SUBJECT: Responses to Request for Additional Information Related to the TRUPACT-III  
Application for Exemption.

REFERENCE: (1) Docket No. 71-9305 & TAC No. L24885  
(2) Application for Exemption for the Model No. TRUPACT-III –Request For Additional  
Information on Environmental Report dated June, 24, 2015, from B. H. White IV to T.  
Sellmer

RE: Responses to NRC RAI on the TRUPACT-III Environmental Report

TRAGIS Route Comparison Figure:

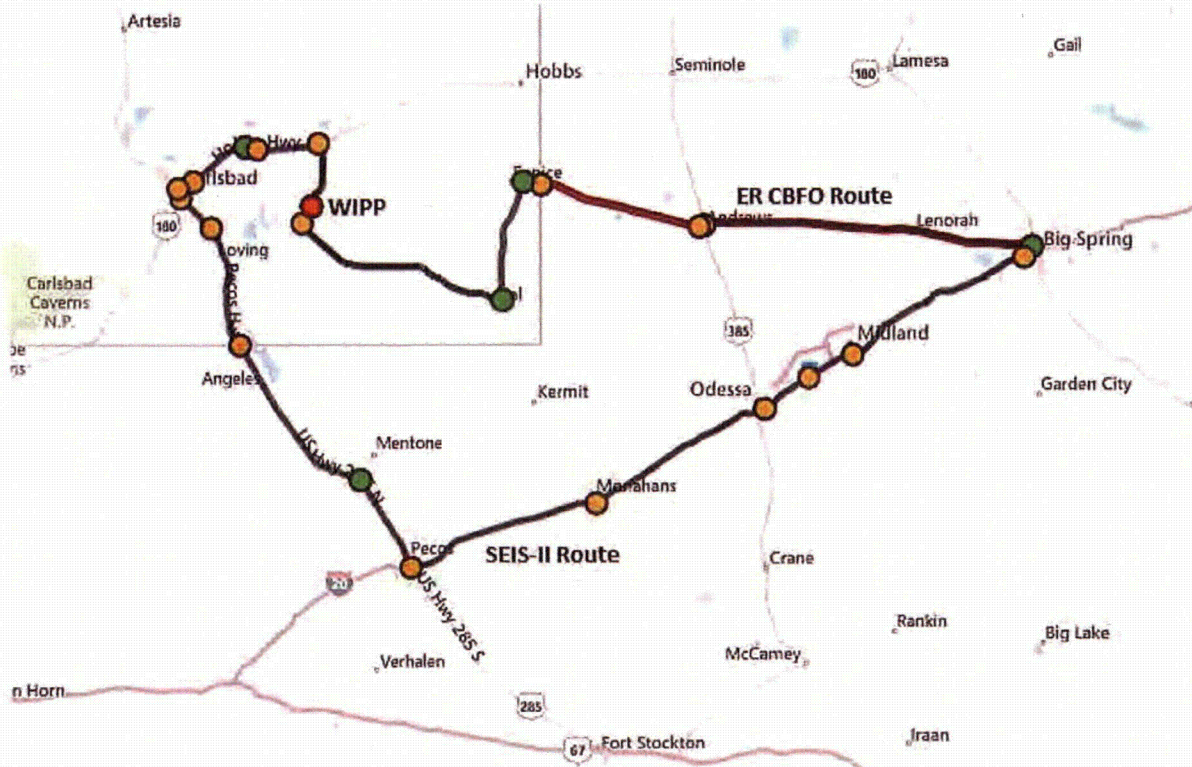
The transportation route listed on page 20 of the environmental report (ER) is slightly different than the route used in the Waste Isolation Pilot Plant Disposal Phase Final Supplemental Environmental Impact Statement (SEIS-II). The route differences begin in Texas. Show how the route provided in the ER is bounded by the route used in SEIS-II (e.g., number of miles, rural vs suburban area, etc.).

As commented, the current ER CBFO route deviates from the SEIS-II route beginning in Big Spring, Texas where a more direct route through Andrews, Texas runs to the south WIPP access road in New Mexico. TRAGIS was used to compare the node to node characteristics between the differing routes (see tabular results and figure illustration below). Starting at the Big Spring, Texas junction, the mileage in Texas and New Mexico following the current CBFO route is approximately 159 miles. Respectively, the total mileage in Texas and New Mexico following the SEIS-II route (SEIS-II, Appendix E, page E-10) is approximately 257 miles. In addition, the distance travelled through populated areas has decreased. This is due to removing the more populated cities of Midland and Odessa, Texas and Carlsbad, New Mexico from the SEIS-II route in preference to Andrews, Texas, and Eunice and Jal, New Mexico. This effectively reduces the population along route areas.

Figure 1(Survey Data for SR313026)

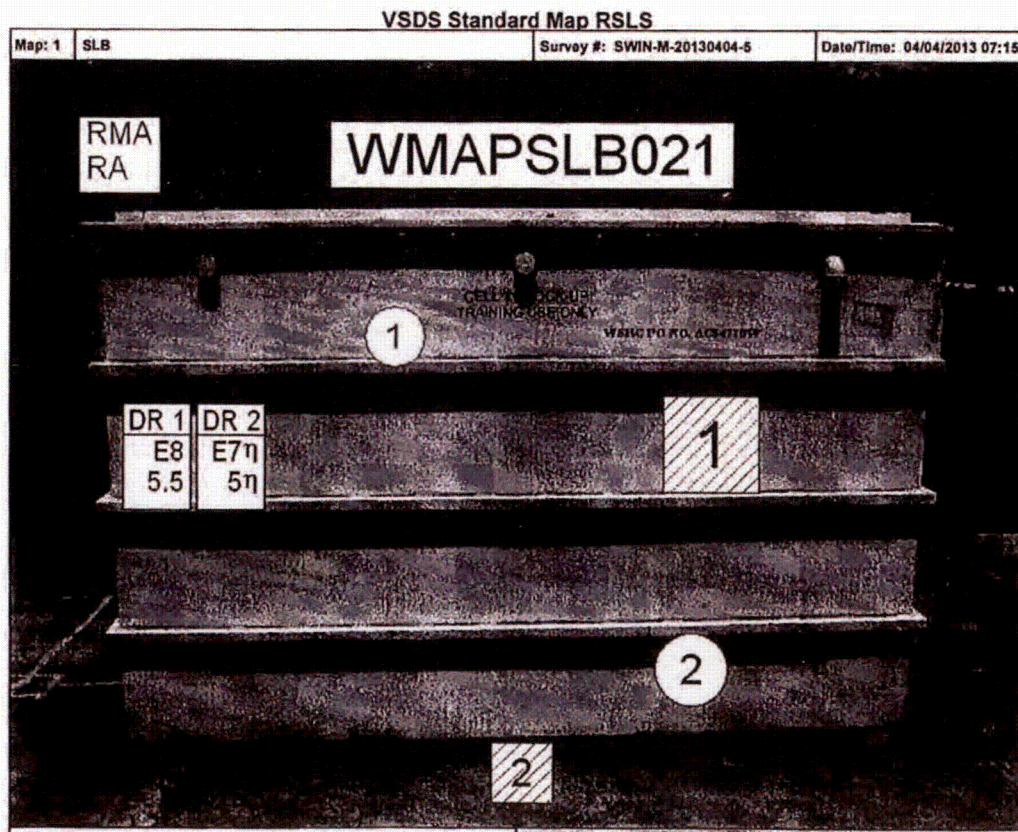
Provide a citation (page number, table number, etc.) for the DOE 1997, DOE 2006, and/or SNL 2009 dose assessments referenced on page 83 in the ER. Show how the dose rates from the two SLB2 waste boxes are bounded by the dose assessments in DOE 1997, DOE 2006, and/or SNL 2009.

Because the SLB2 containers in the proposed action have not been loaded into a TRUPACT-III at this time, a direct comparison of 1m dose rates on the transport container (the Transportation Index, or TI) as detailed in DOE 1997 or DOE 2006 is not presently possible. However, a comparison of the data from Table 4.12-1 (dose rates of the SLB2 containers in the proposed action) and Table 4.12-2 (dose rates on SLB2 containers in compliant shipments of the TRUPACT-III) provide evidence that the proposed action will not result in radiological consequences that exceed the EIR analysis of record.
